Sustainable Communities Environmental Assessment Errata

5001 Wilshire Project

Case Number: ENV-2021-3327-SCEA
DIR-2021-3324-CLQ, DIR-2021-3326-TOC-SPR-VHCA, VTT-83358

August 2022

FIGURE II-5

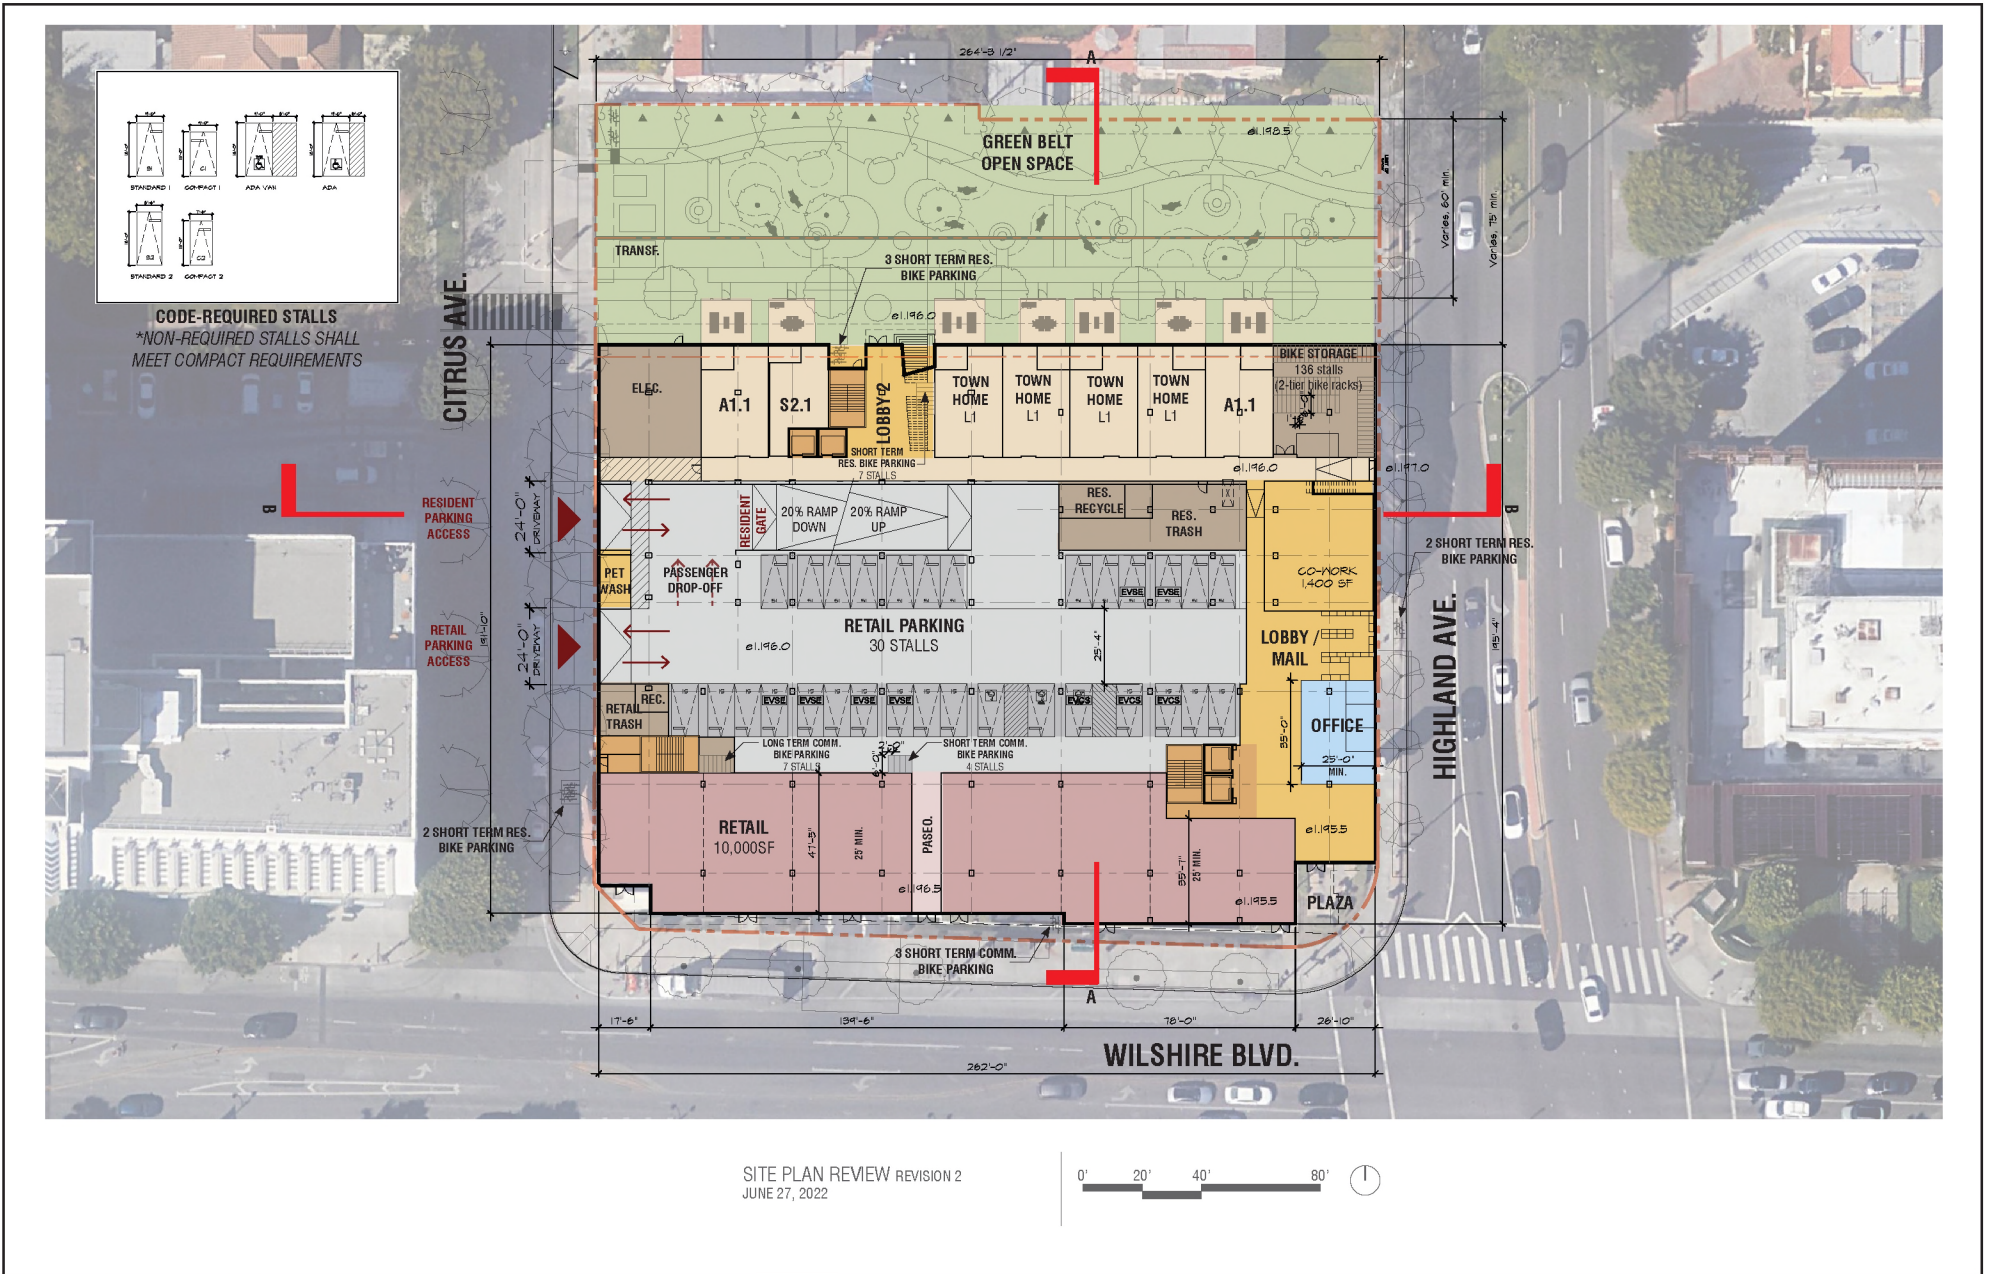
Figure II-5 Site First Floor Plan – this figure reflects minor updates made to the unit mix and their location, and updates to the bicycle parking and storage locations.

FIGURE II-6

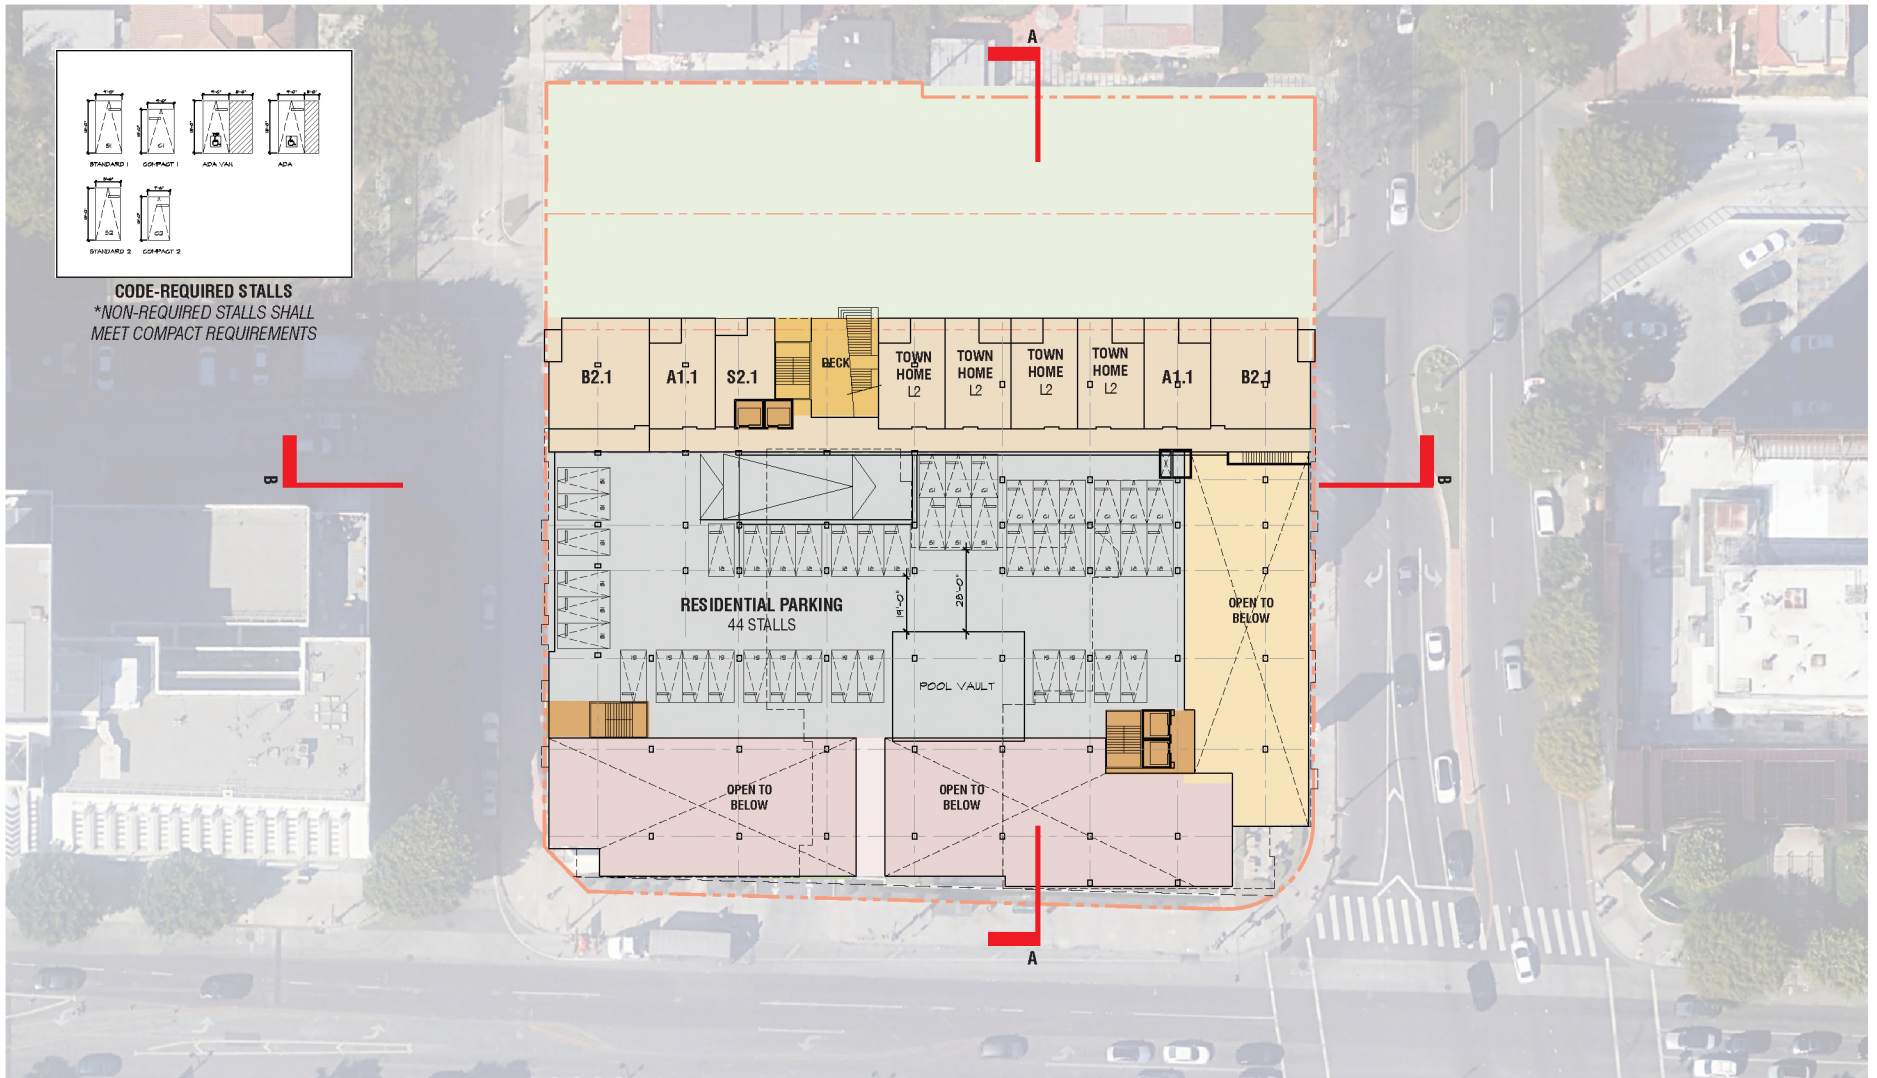
Figure II-6 Second Floor Plan – this figure reflects minor updates made to the unit mix, storage area locations and the addition of residential parking spaces on this above-grade level.

FIGURE II-7

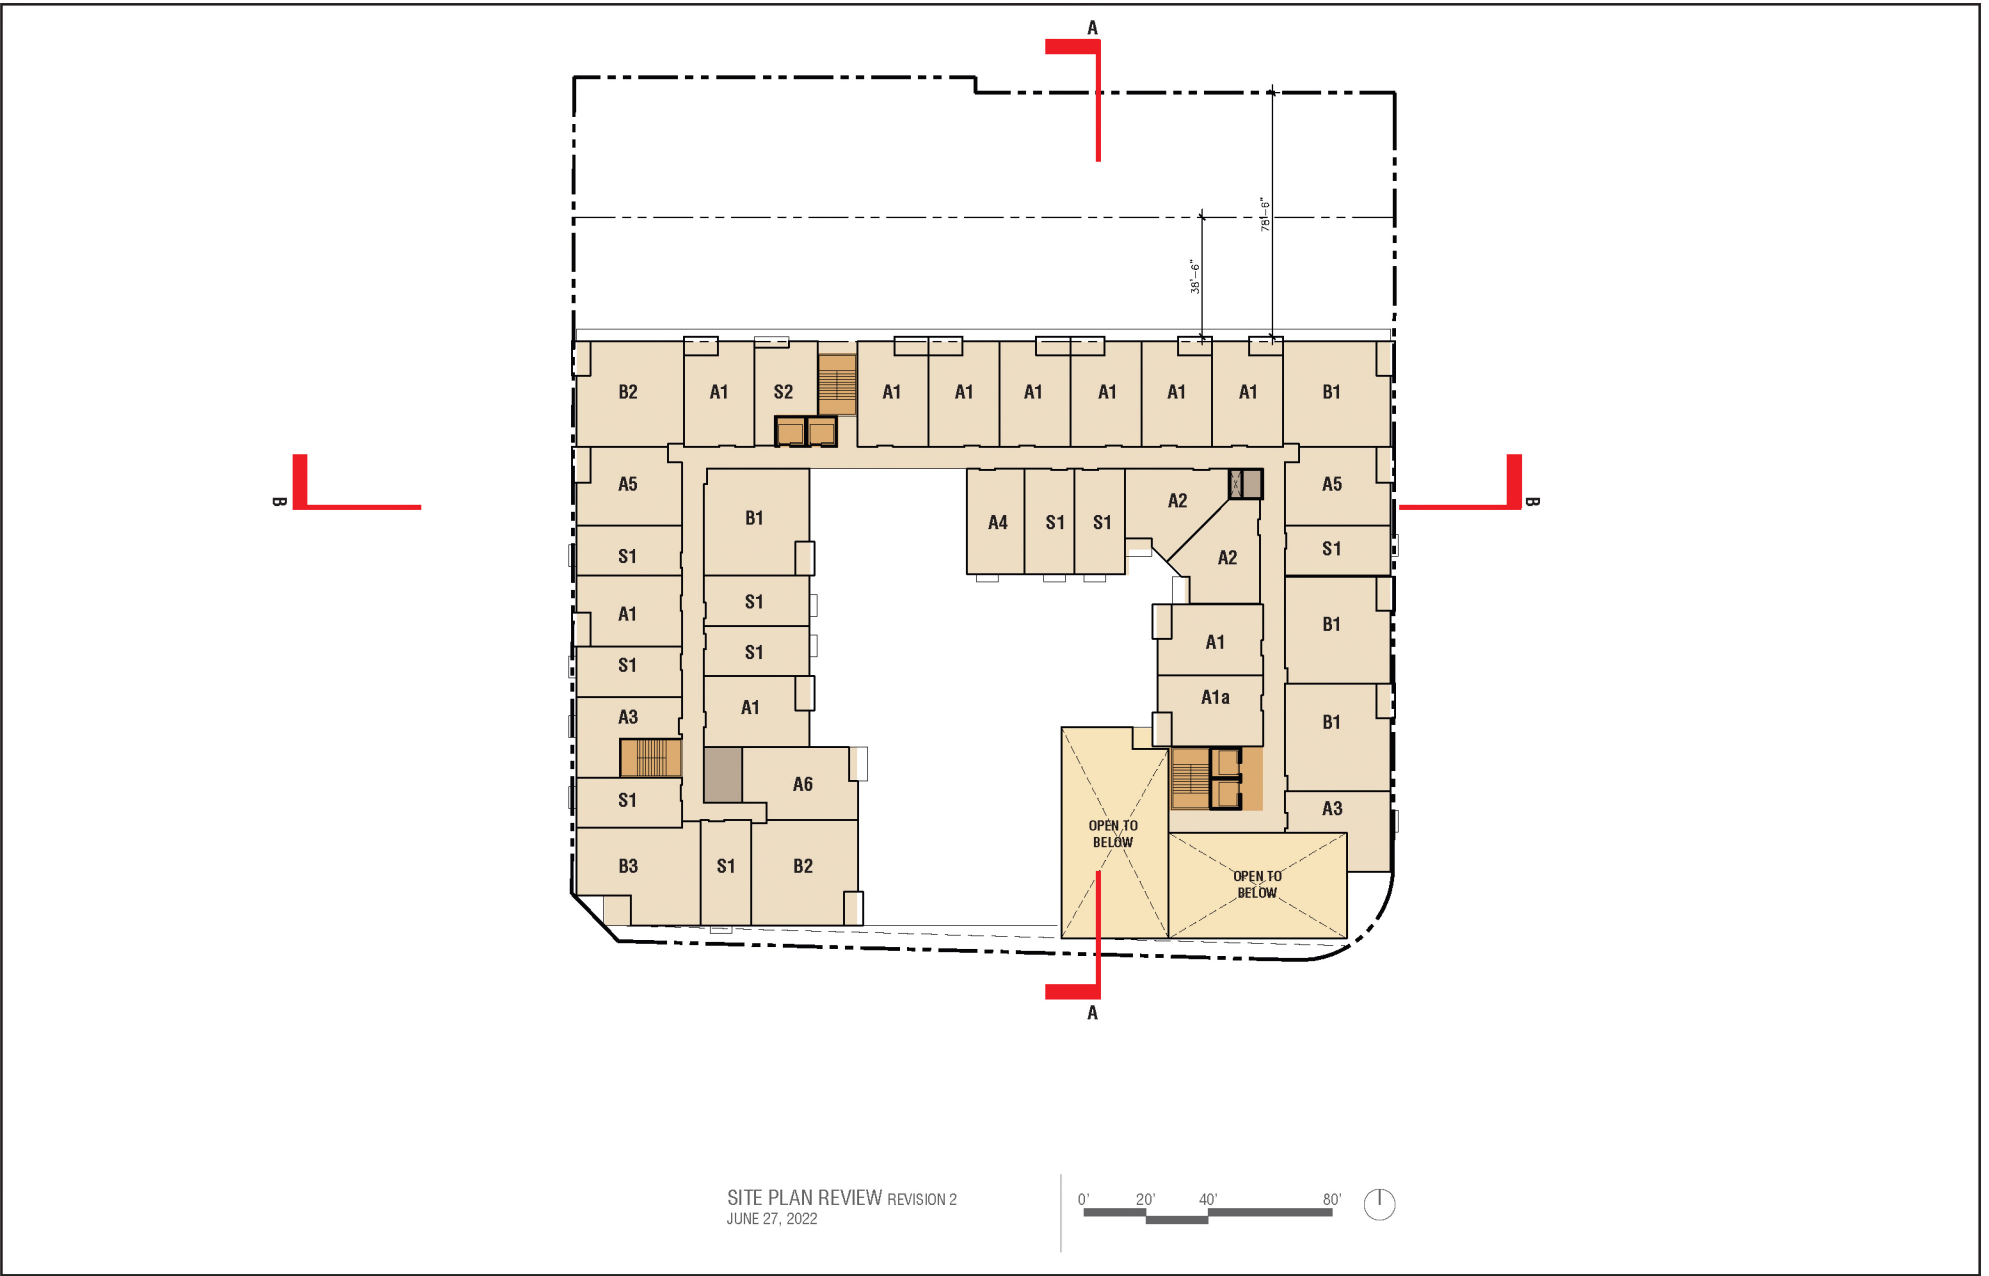
Figure II-7 Third Floor Plan - this figure reflects minor updates made to the unit mix and their location, and updates to the indoor amenities and their location.

FIGURE II-8

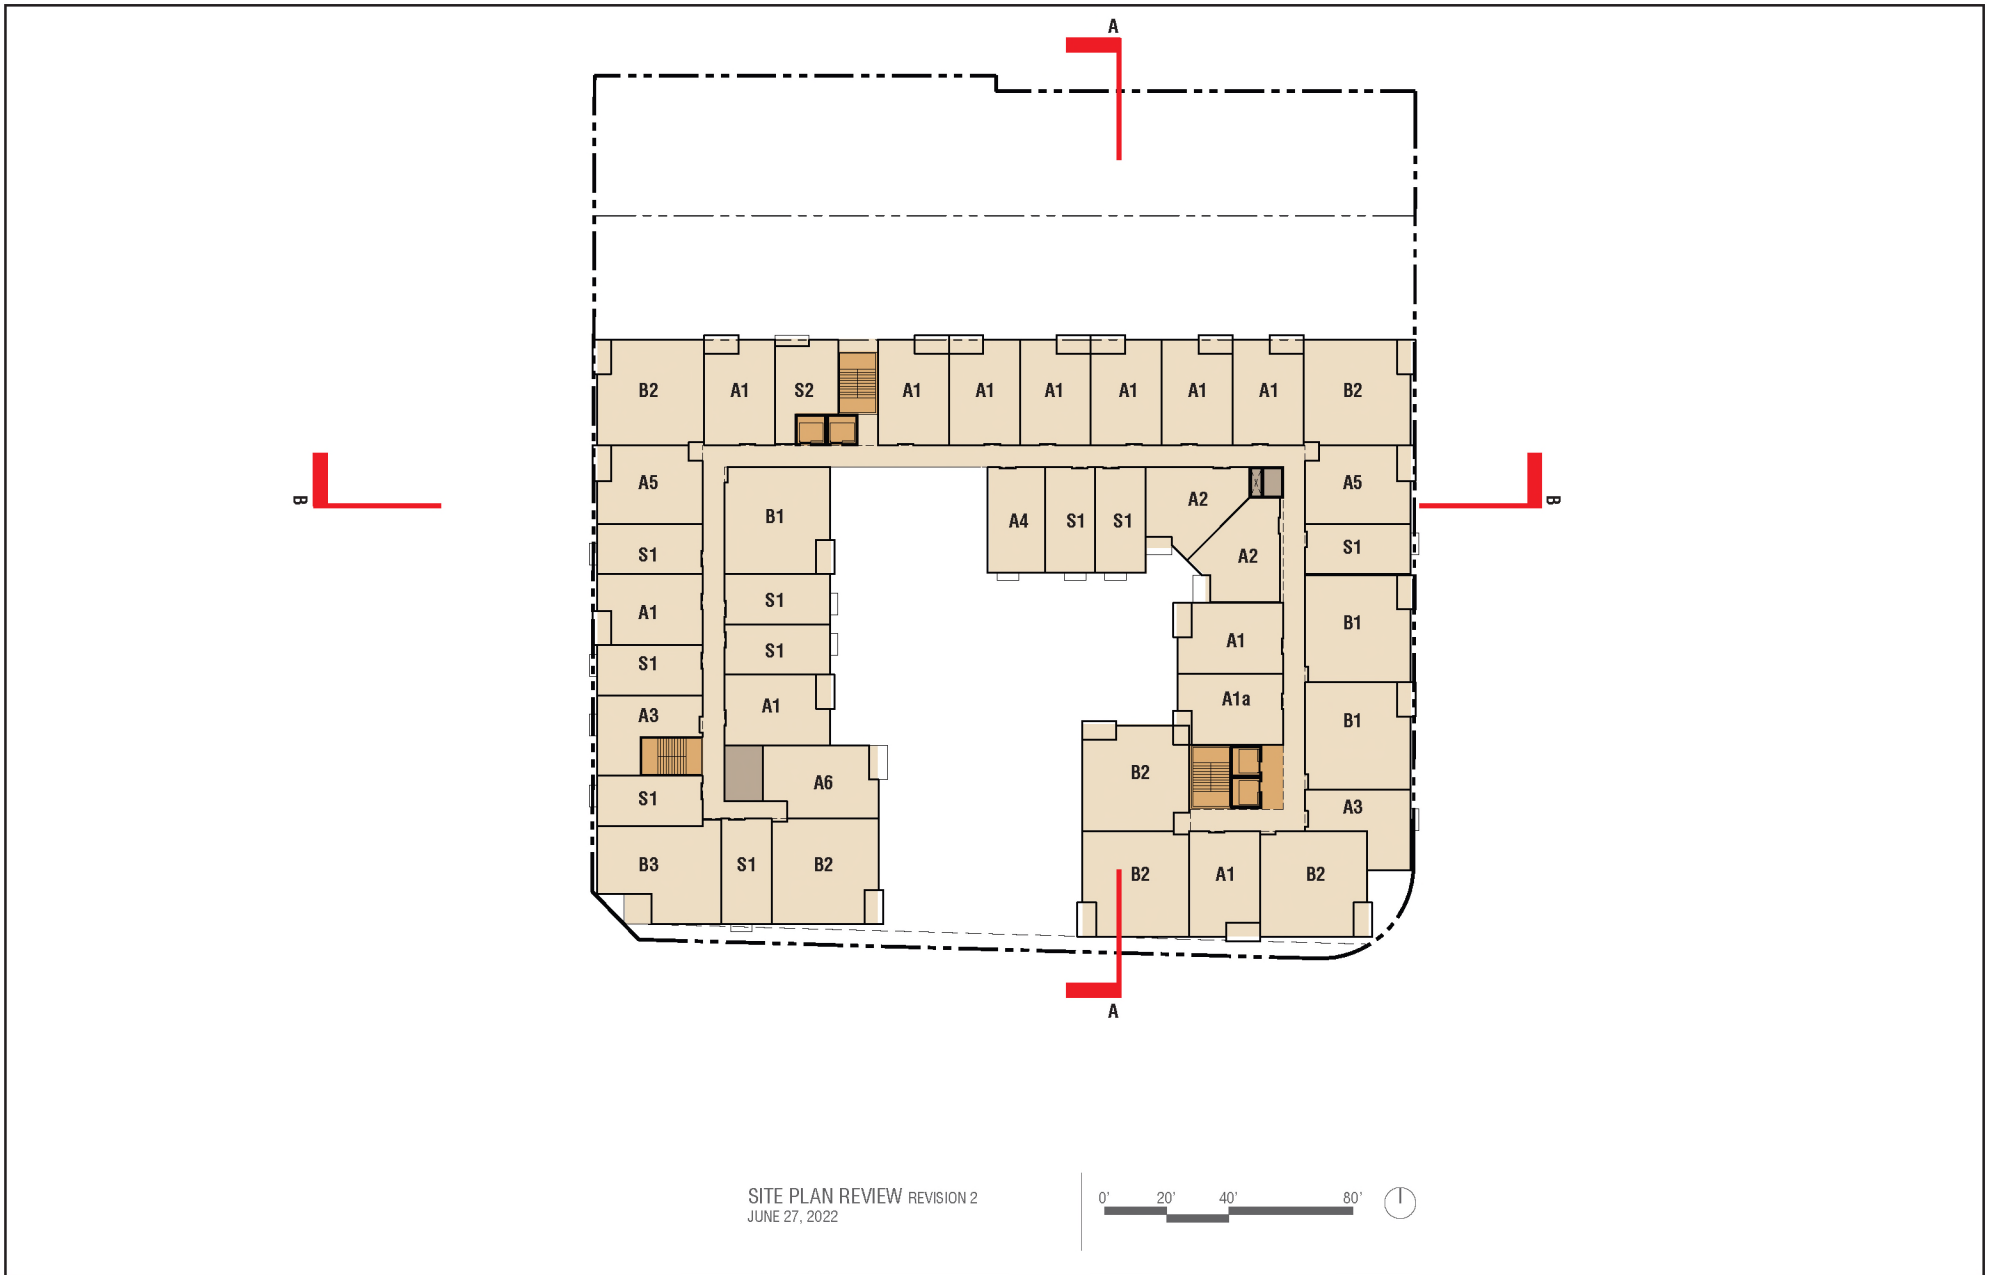
Figure II-8 Fourth Floor Plan - this figure reflects minor updates made to the unit mix and their location, and updates to the indoor amenities and their location.

FIGURE II-9

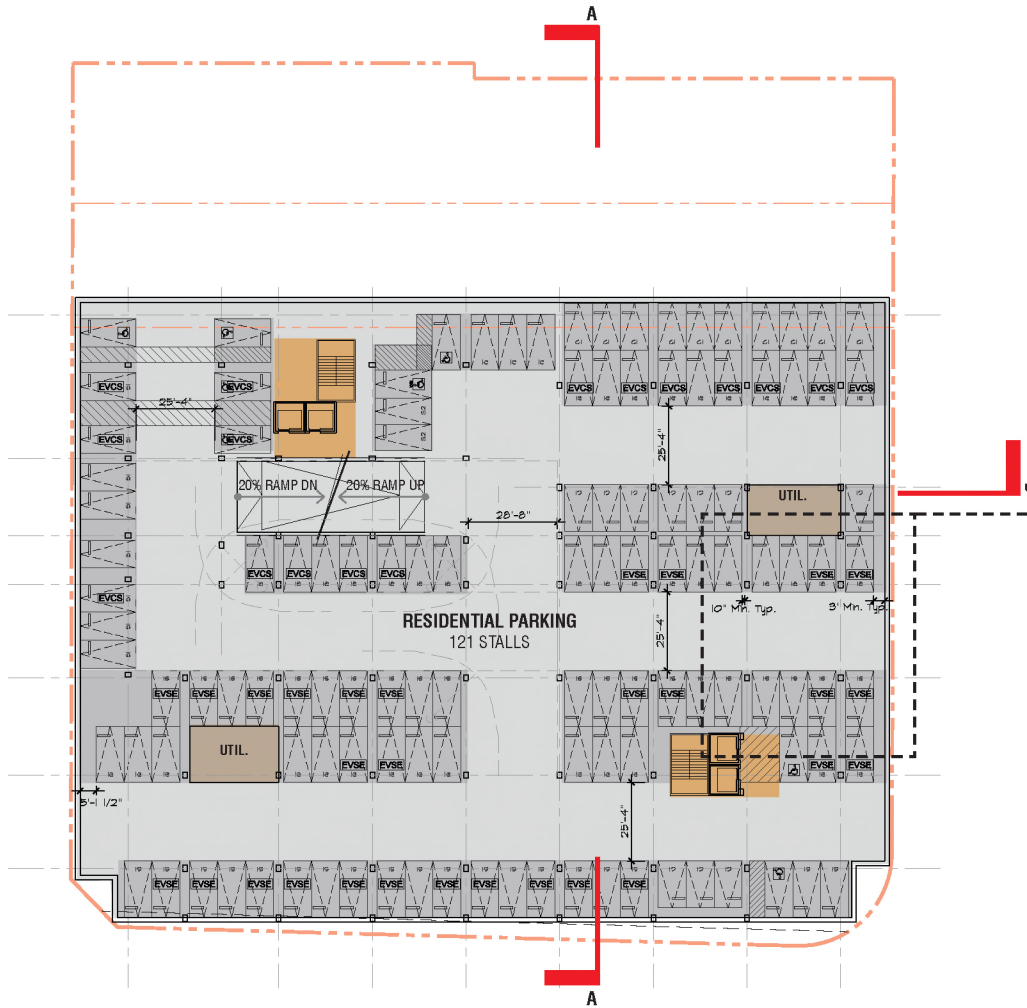
Figure II-9 Typical (Fifth - Eighth) Floor Plan - this figure reflects minor updates made to the unit mix and their location.
